## LOCAL MEMBER OBJECTION

APPLICATION No. **17/01253/MNR** APPLICATION DATE: 01/06/2017

LOCATION: 212 CYNCOED ROAD, CYNCOED, CARDIFF, CF23 6RS

PROPOSAL: PROPOSED DEMOLITION OF EXISTING DWELLING & ERECTION OF NEW DEVELOPMENT TO FORM 5 FLATS

DRAWING NUMBER	REVISION
P458a L_210	B

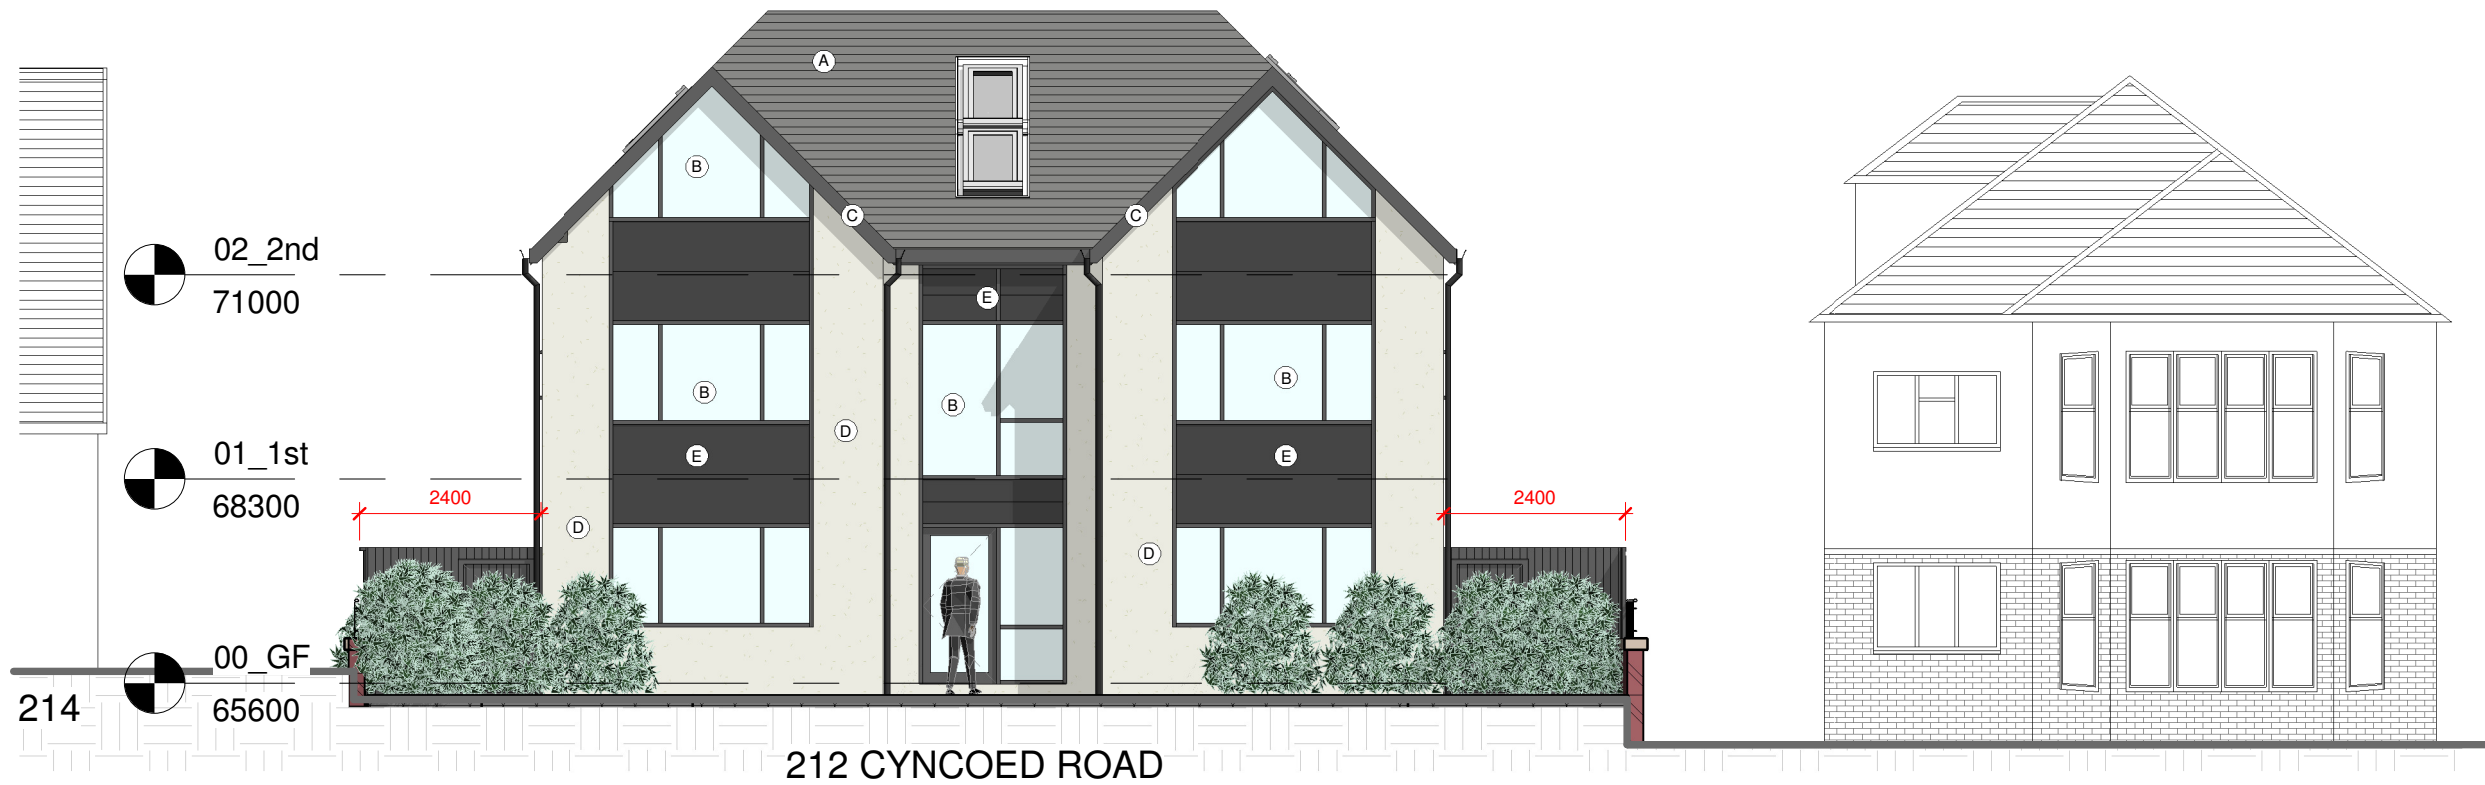
*The provision of “Juliet” balconies on the first floor and non-obscure windows on the third floor east facing elevations will, by virtue of the proximity of the apartments to the boundaries and the increased height of the building, provide uninterrupted views into neighbouring properties, outdoor recreation areas and gardens and will compromise the privacy of residents living at these properties. The “Cardiff Residential Design Guide” Supplementary Planning Guidance at page 53 states: “A privacy distance of at least 21 metres will be required between facing windows to habitable rooms on the private side of a development”.*

- 8.14 The extent that the building projects rearwards into the site has been significantly reduced when compared to the footprint of the building subject of the previous planning application for 7 no. flats ( by approximately 9.0 metres). The scheme does not propose a rear parking area which was a previous concern. To protect the privacy of neighbours, first floor windows in the side elevation and a number on the rear elevation are conditioned to be obscurely glazed.

- 8.15 Whilst some concern has been raised regarding upper floor windows overlooking neighbouring gardens, especially as a number would serve habitable rooms, a degree of mutual overlooking is inevitable in such residential areas and it is not considered that the impact of the revised proposal on the privacy of the neighbouring occupiers would be so significant as to justify refusal of the application on this ground or that the proposed building, as amended, would have an unduly overbearing effect on the adjoining neighbours.

SCALE	DATE	DRAWN BY	CHECKED BY
1 : 100	17/05/17	PL	GH
DRAWING NUMBER	REVISION		
P458a L_200	B

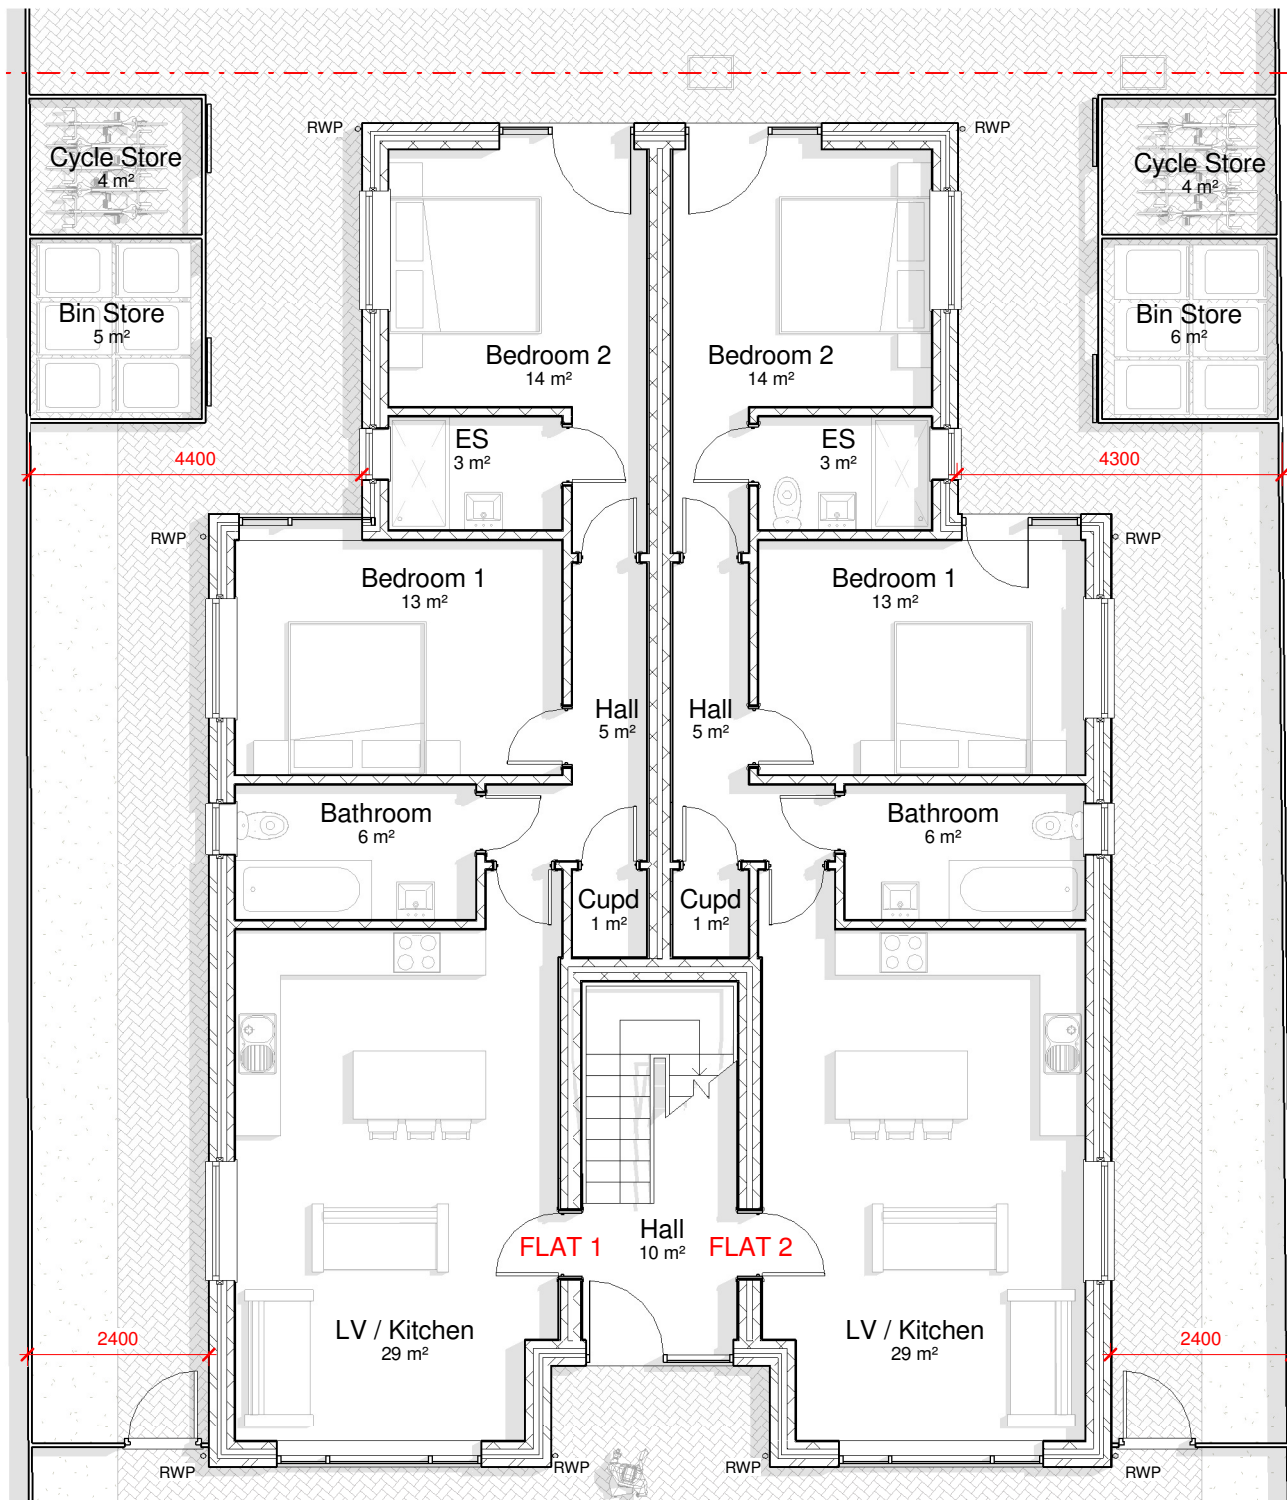
- 8.16 The neighbour's concern regarding the location of the bin store next to the boundary with 210 Cyncoed Road is noted. The revised layout plan proposes two combined bin and cycle stores located next to the boundaries with nos. 210 and 214 rather than a single bin store next to 210 Cyncoed Road. The stores will be screened from the neighbours' view by proposed boundary fencing. On this basis, it is not considered that refusal of the application on amenity grounds would be justified.
